**RE: Hanson Sancrox Quarry SSD Application No. 7293**

Accordingly, we wish to make the following submission on the proposed Hanson Sancrox Quarry expansion SSD No. 7293 documentation:

"C"

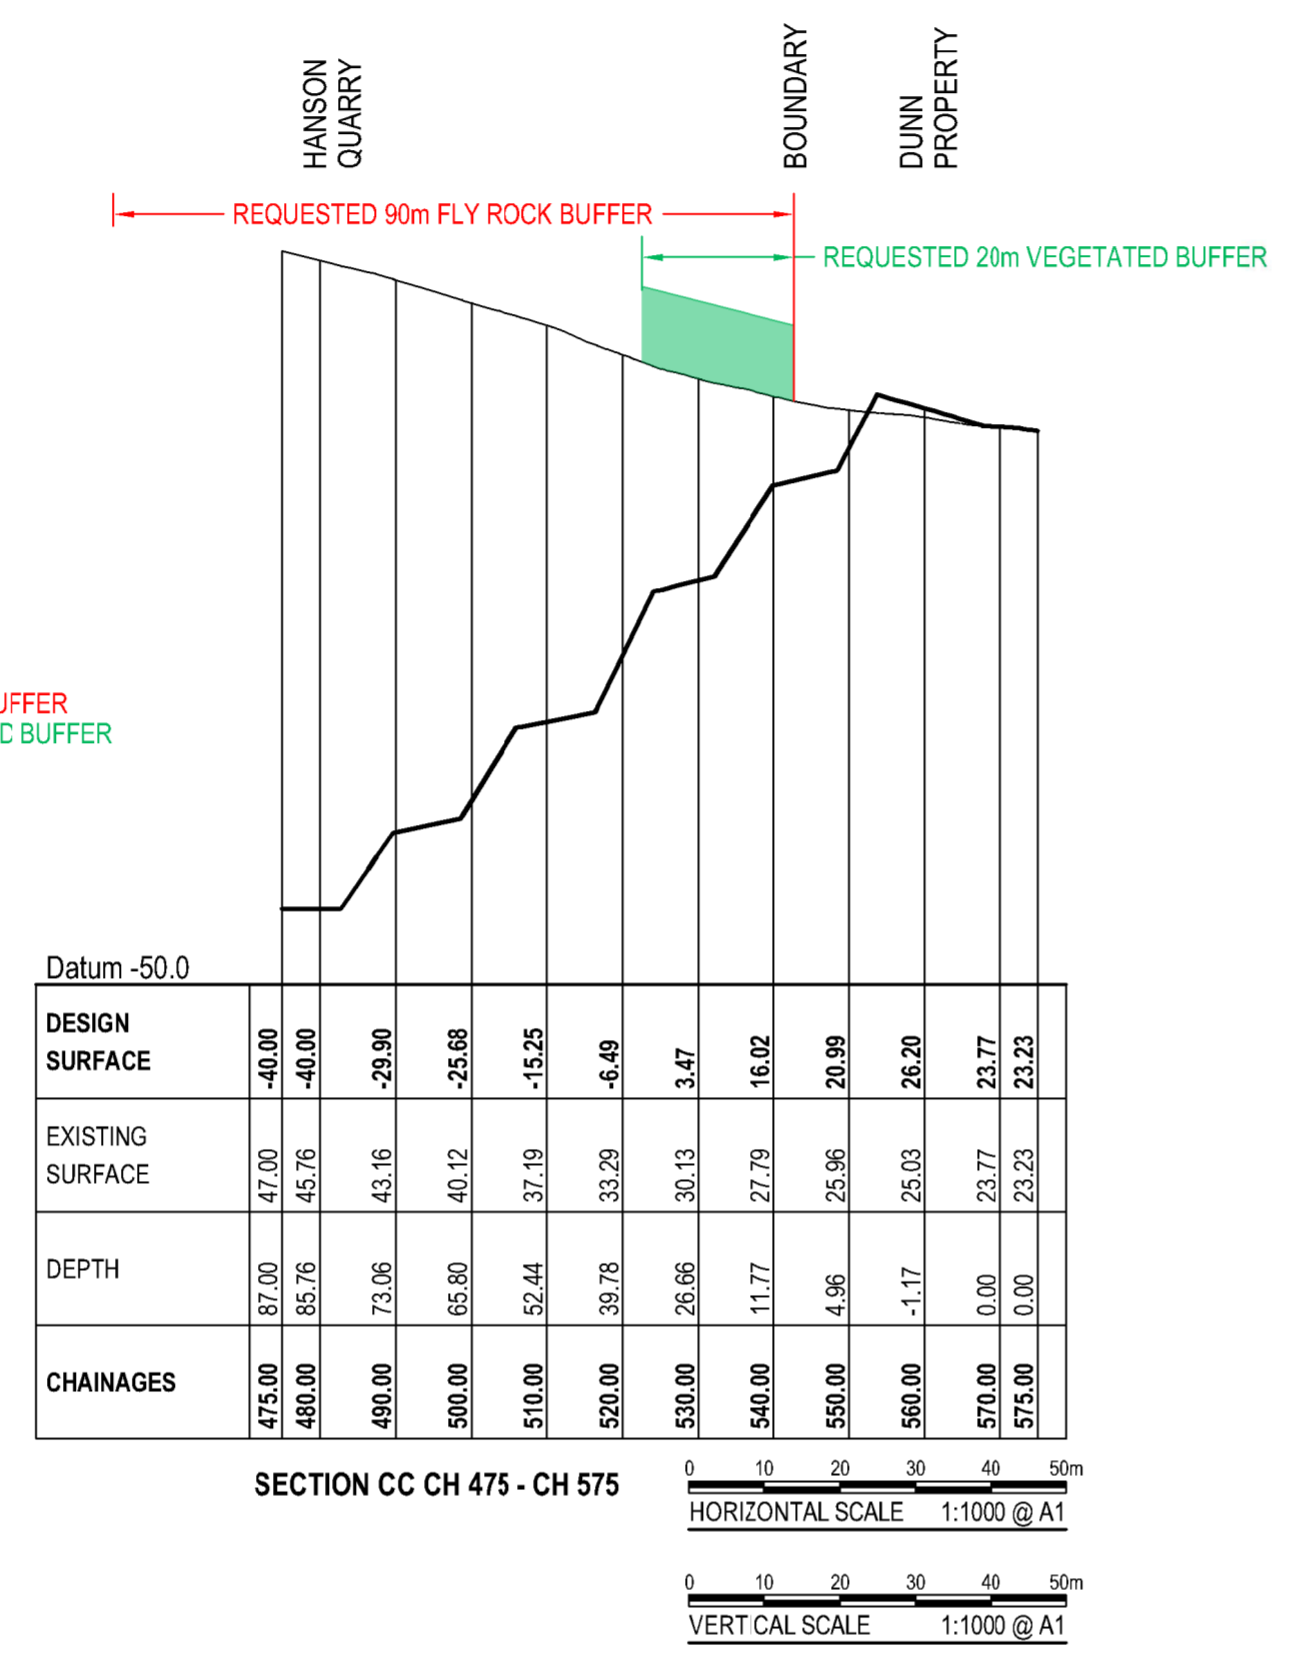
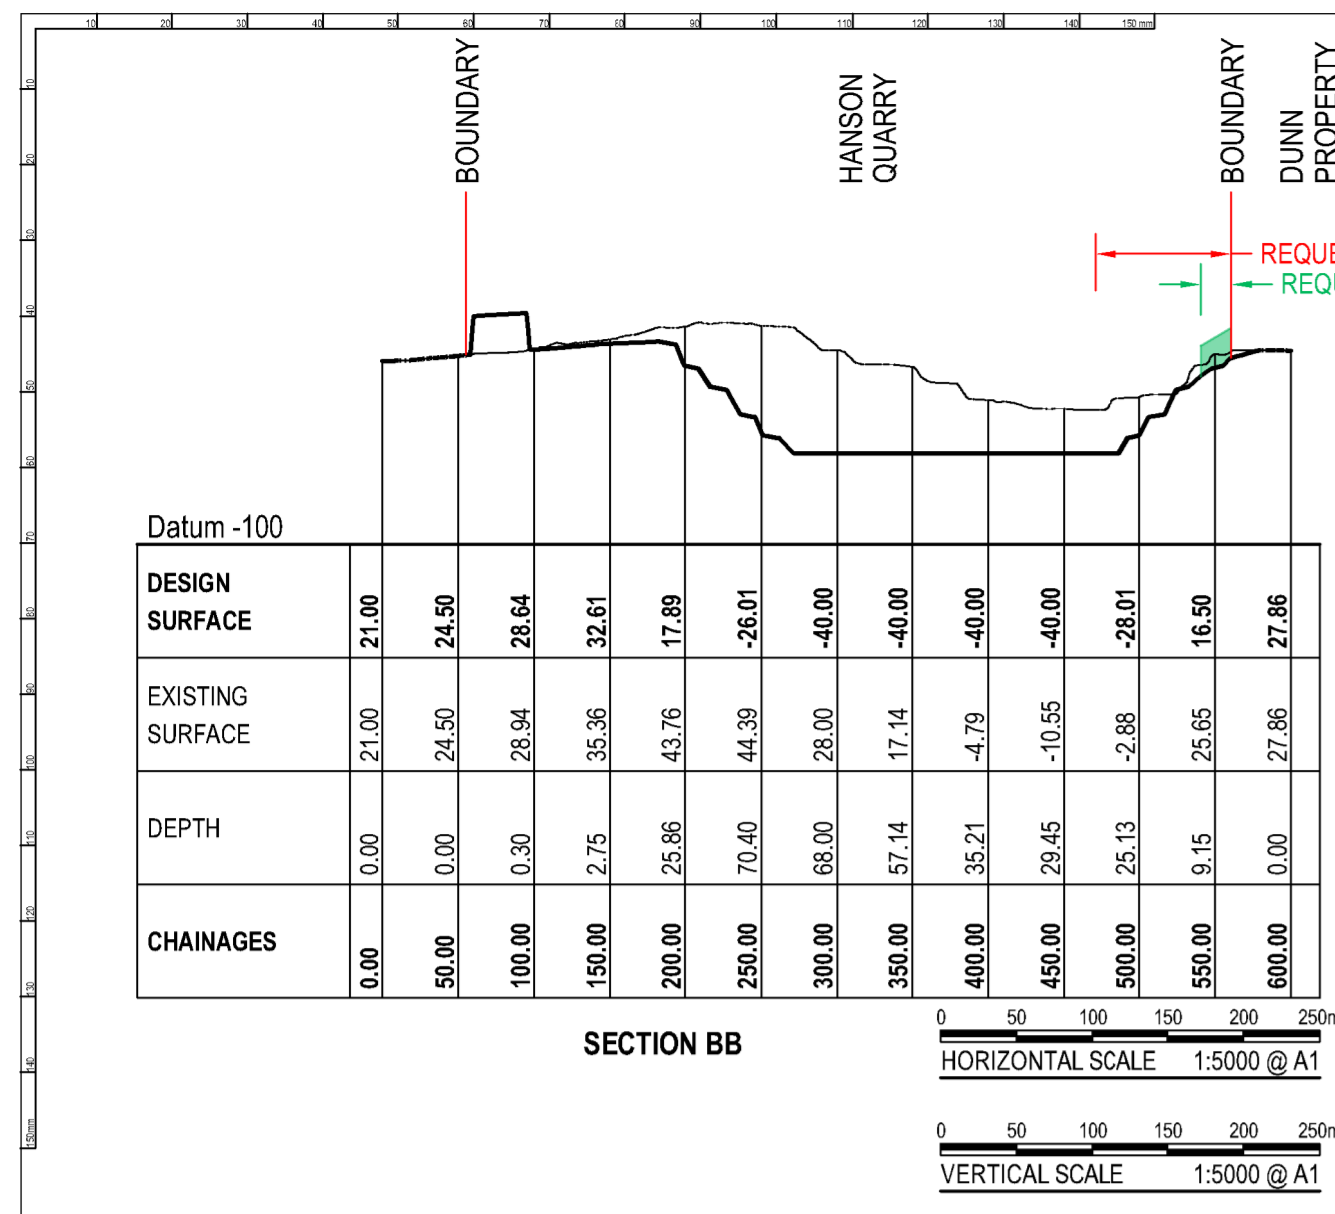
More importantly, the proposal does not provide any flyrock buffers and these must be contained within quarry property. The SKM/Terrock report calculated a 90m buffer for flyrock and accordingly any proposed blasting should be at least 90 metres from the Southern boundary of our property and the proposal should be modified accordingly.

<b>Proposed Study Area</b>		<b>F5.1</b>
Drawing No: 0418291s_EIS_C004_R0.cdr	Sancrox Quarry Expansion Project	
Date: 28/08/2016	Drawing size: A4	Client: Hanson Construction Materials Pty Ltd
Drawn by: VN	Reviewed by: TB	
0 100 200m		 ERM
N

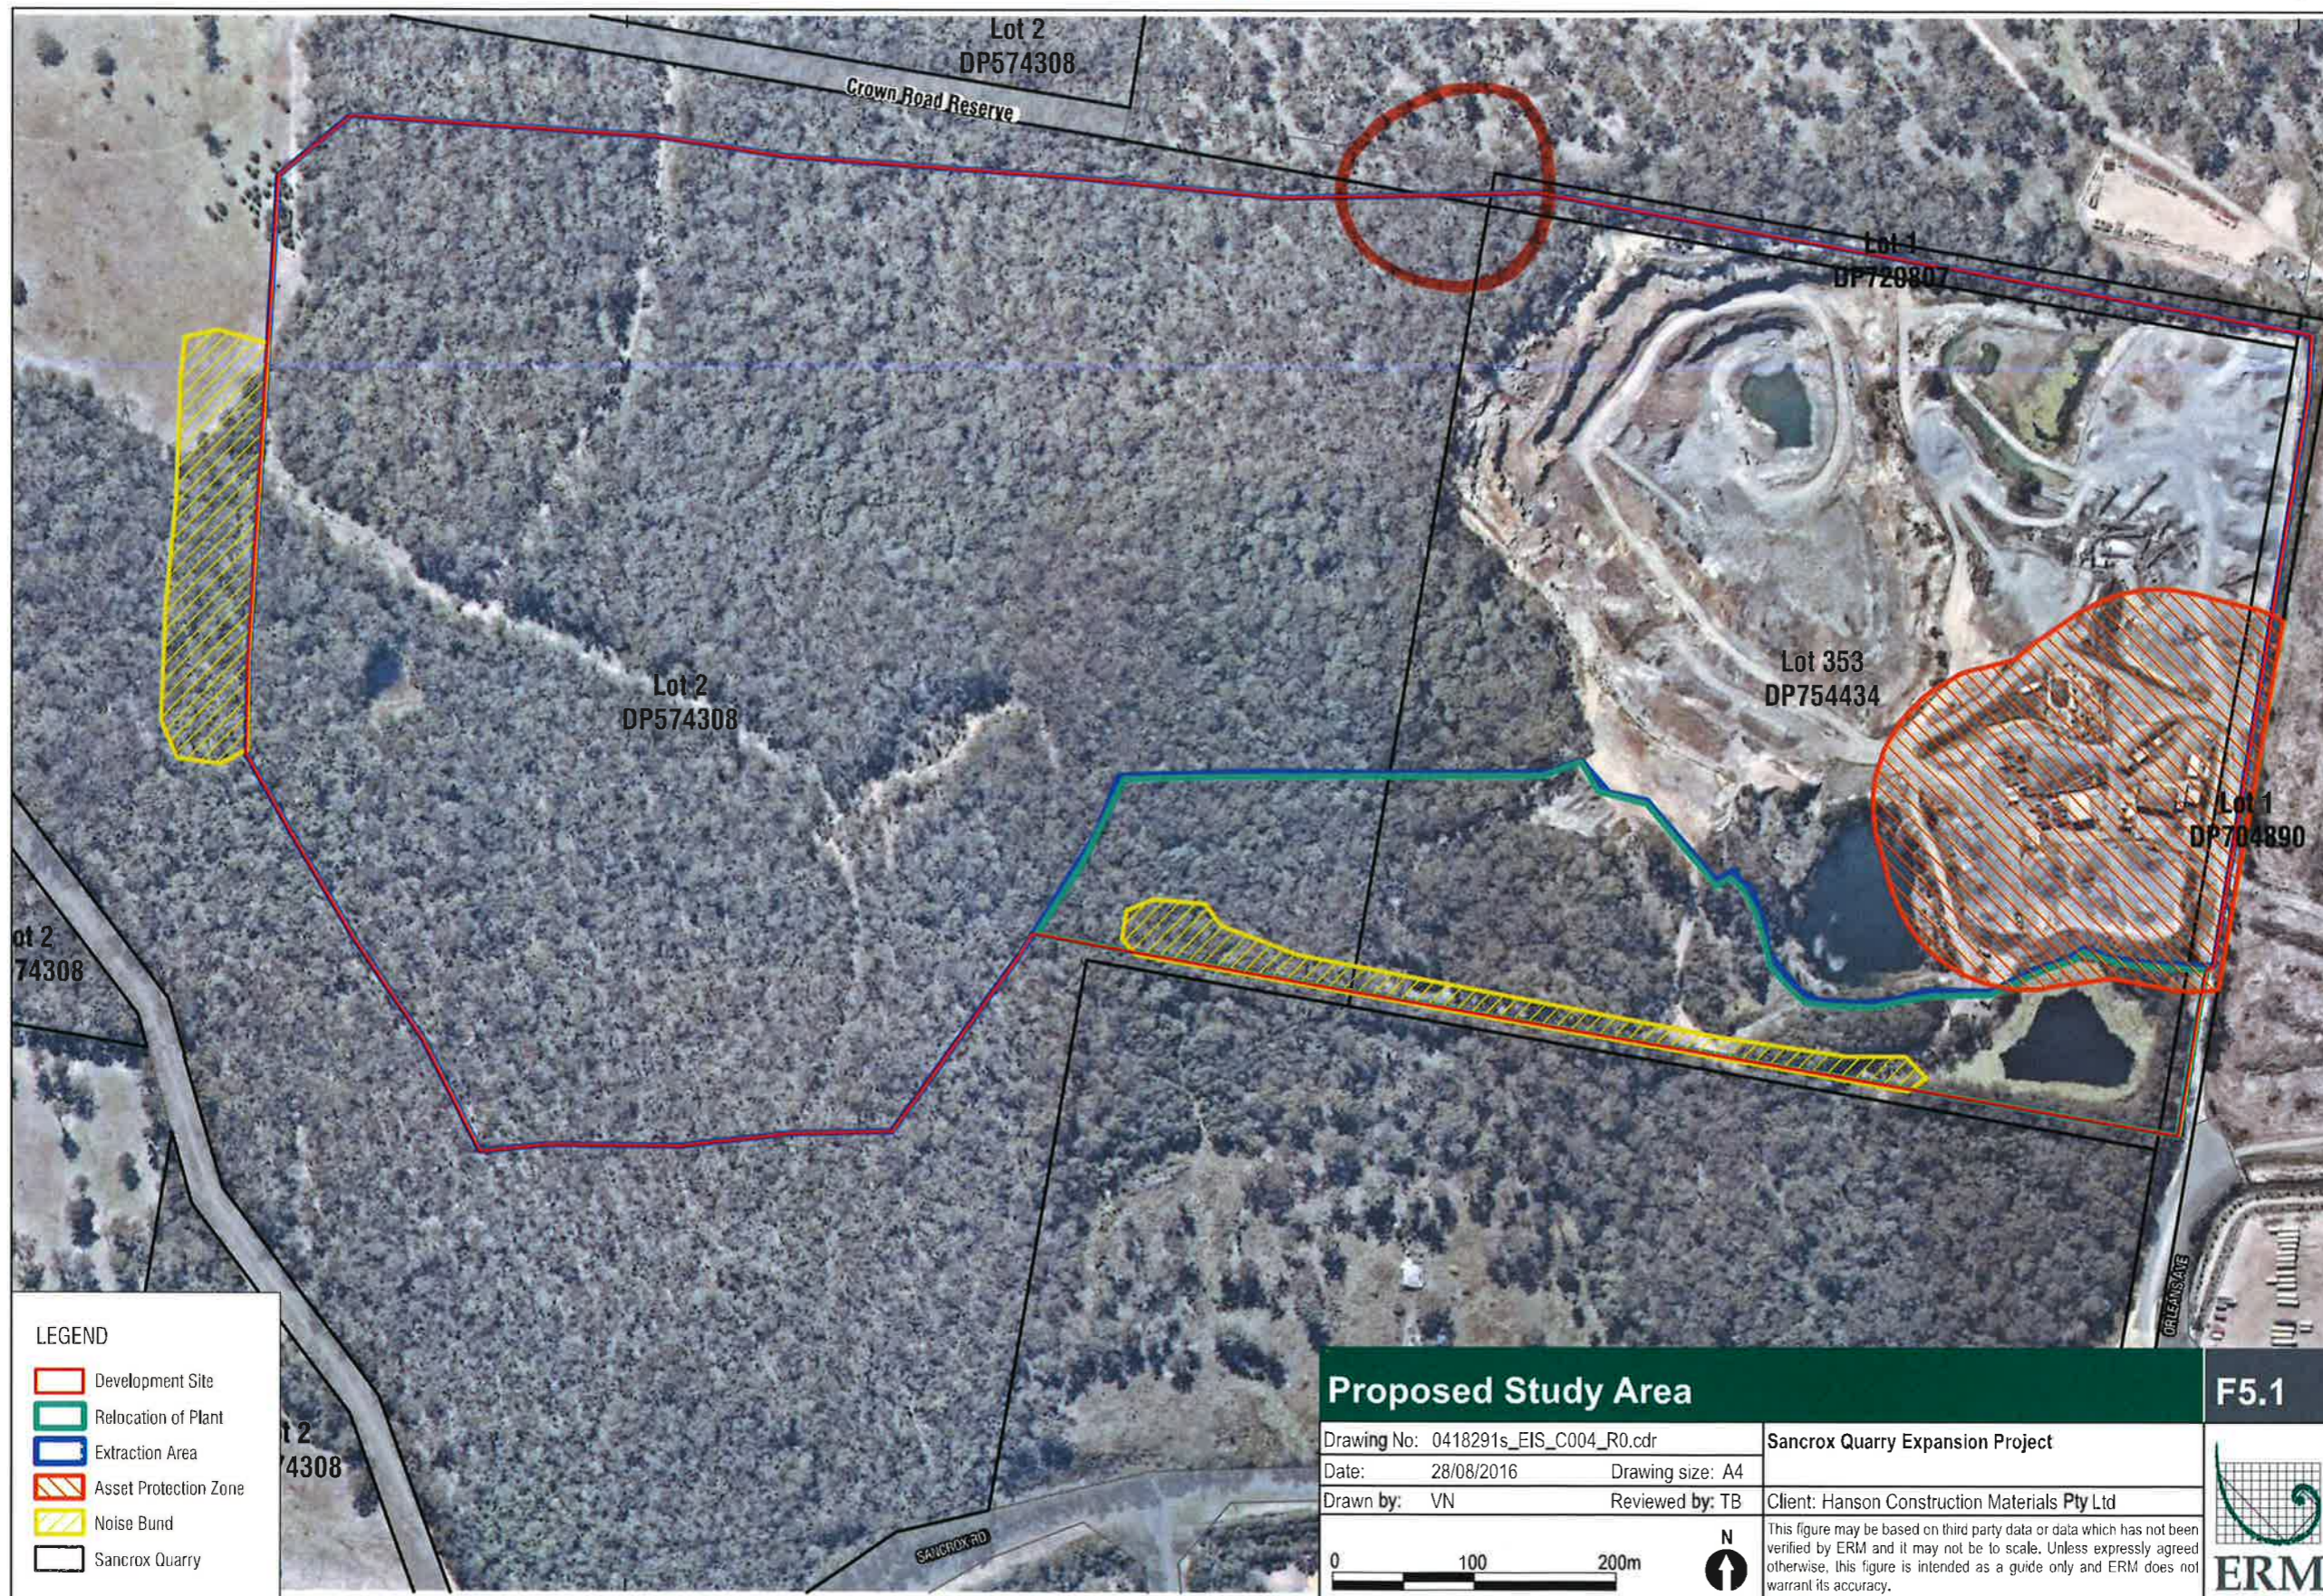
For example see attached at "G" is a marked-up Proposed Study Area – Figure 5.1 and a marked up Quarry Staging – Figure 2.3. Both these figures clearly indicate excavation on our property.

**Connectivity Value - Pre-Development Site Connecting Links (Current linkage widths)**

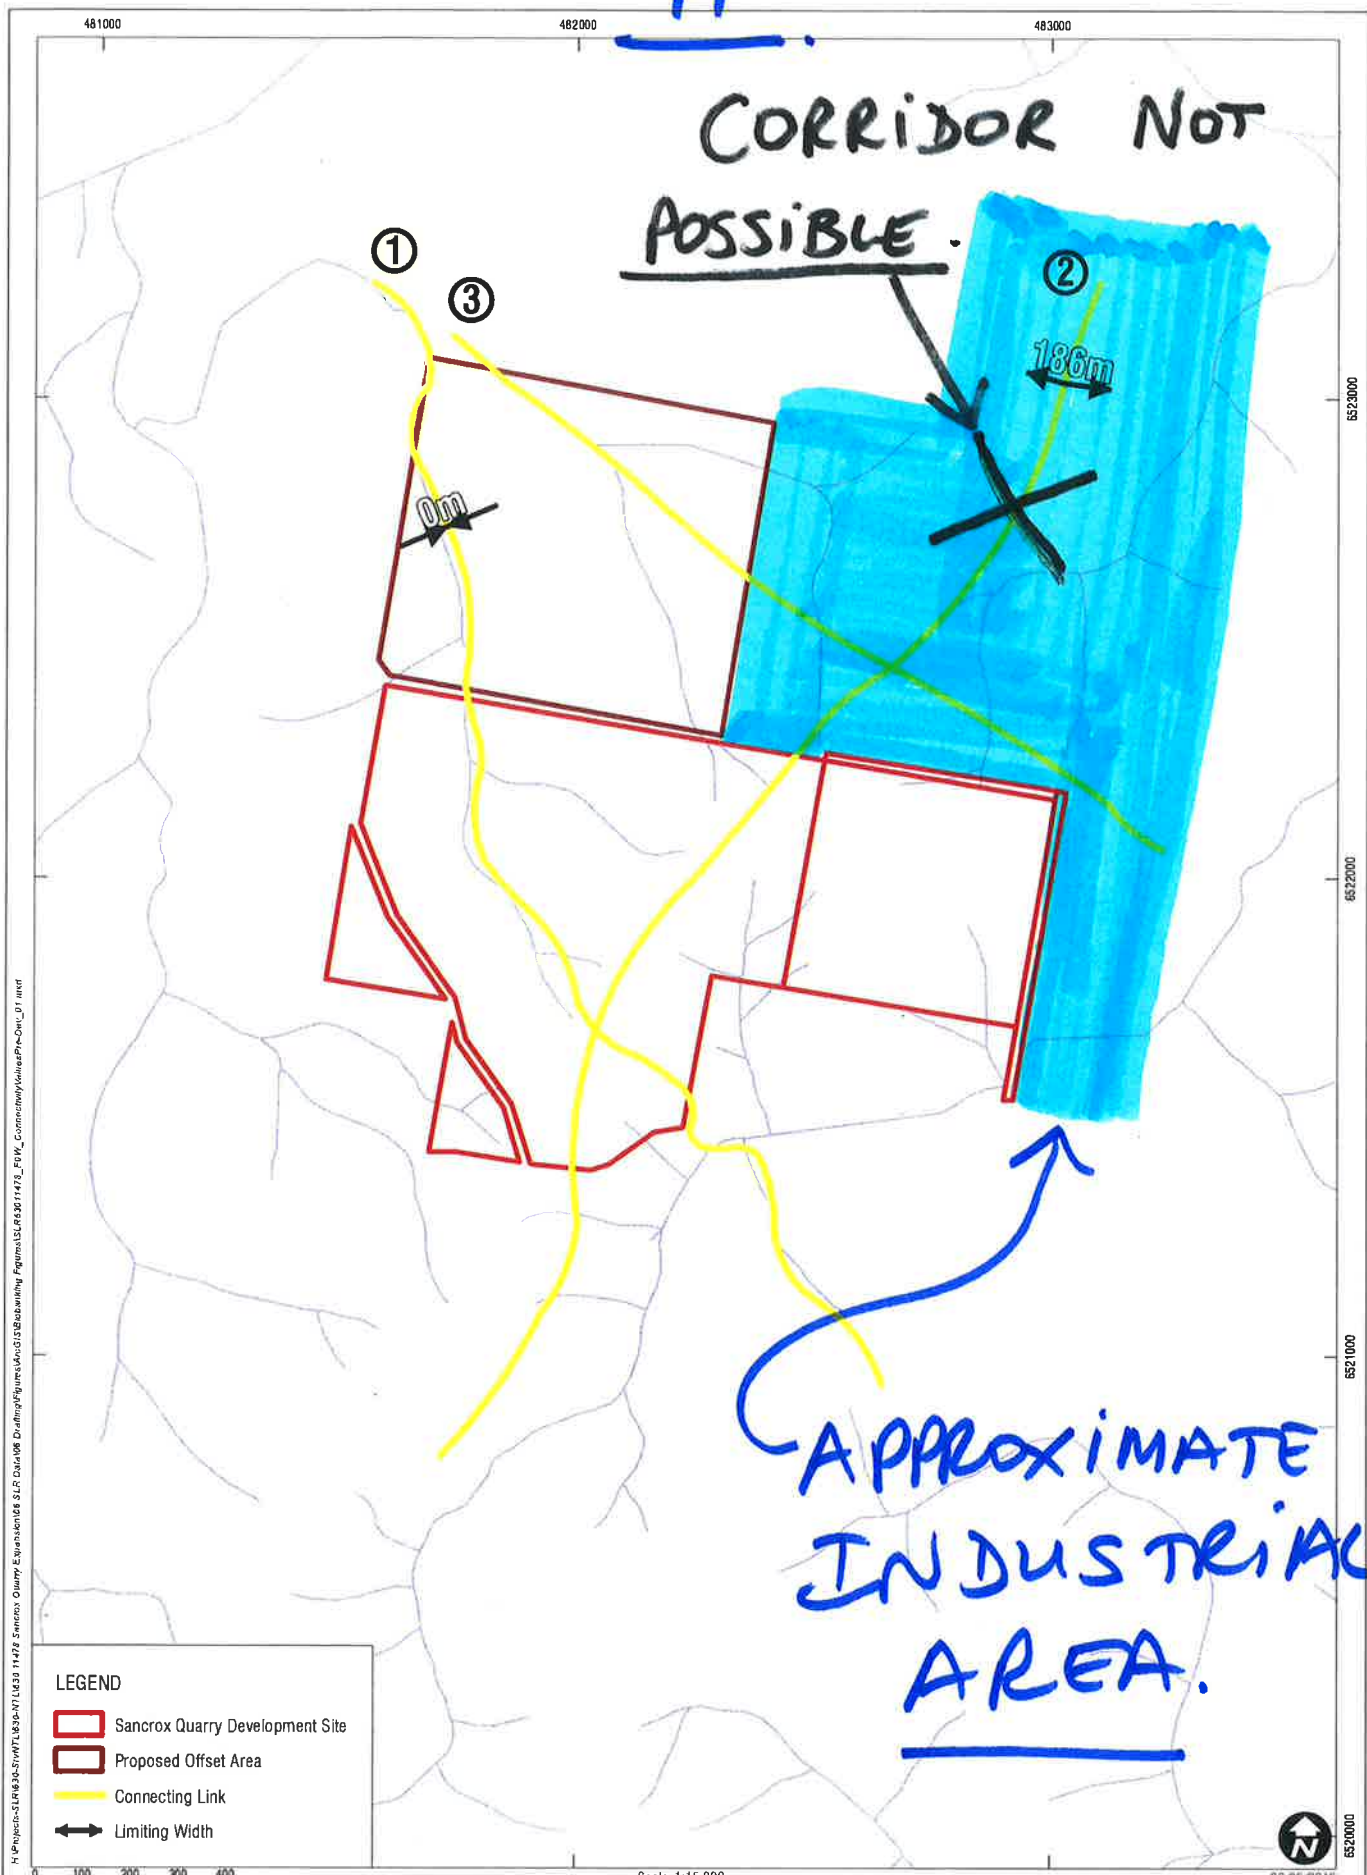
The connectivity plans or corridor plans (marked-up copies attached at "H") created by SLR show a distinct lack of understanding of what is already approved and what is reality on neighbouring properties.

CORRIDOR NOT POSSIBLE.
